Revised PM_{2.5} 1 LPM cyclone inlet design

Access Sensor Technologies has improved the design of our PM_{2.5} 1 LPM cyclone inlet to achieve a penetration efficiency that aligns more closely with the United States Environmental Protection Agency (US EPA) definition of PM_{2.5} (Figure 1).

Figure 1: Penetration efficiency vs. aerodynamic diameter for the new (R1) and old (R0) PM_{2.5} 1 LPM cyclone inlet designs compared to the US EPA definition of PM_{2.5}.

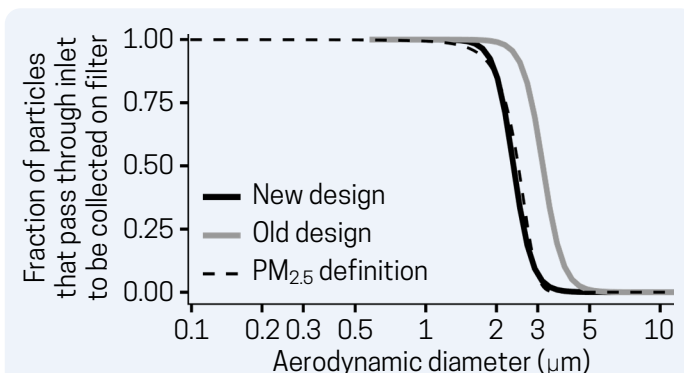
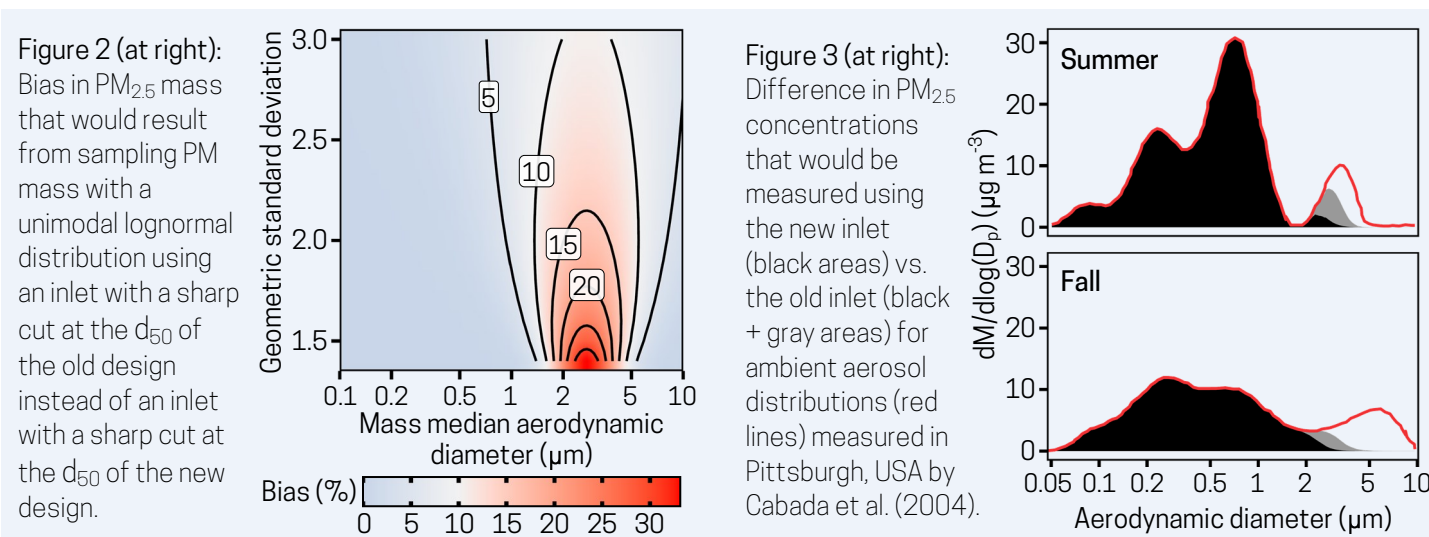
Recent tests indicated that the old (R0) design had a cutpoint (d_{50}) that was closer to 3.0 μm than to 2.5 μm .

Figure 4. Compare plastic insert on the bottom side of your PM_{2.5} 1 LPM inlet to these images to determine whether the inlet uses the old (R0) or new (R1) PM_{2.5} 1 LPM cyclone design.

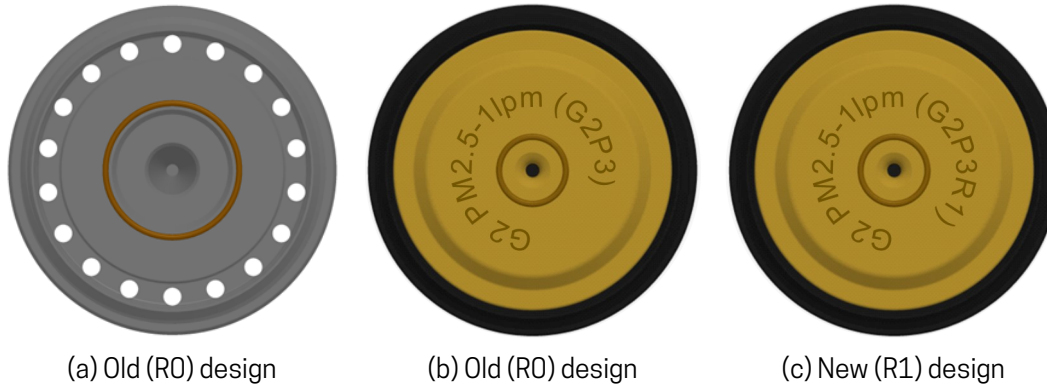
How will I know which PM_{2.5} 1 LPM inlet design I am using?

Compare the bottom side of the inlet, paying special attention to any text engraved there, to Figure 4 and Table 1.

NOTE: For GEN2P3 inlets, the engraving on the top side of the black aluminum cap might differ from the engraving on the bottom side of the brown plastic insert. For example, the cap might be engraved with “GEN2P3R0” and the insert might be engraved with “GEN2P3R1”. Such a discrepancy does not indicate a problem. The design change discussed in this technical bulletin affects the plastic insert; therefore, the engraved text on the bottom of the plastic insert is what indicates whether the inlet uses the old or new PM_{2.5} 1 LPM cyclone design. GEN2P3R1 inserts, which feature the new design, are compatible with all GEN2P3 caps.
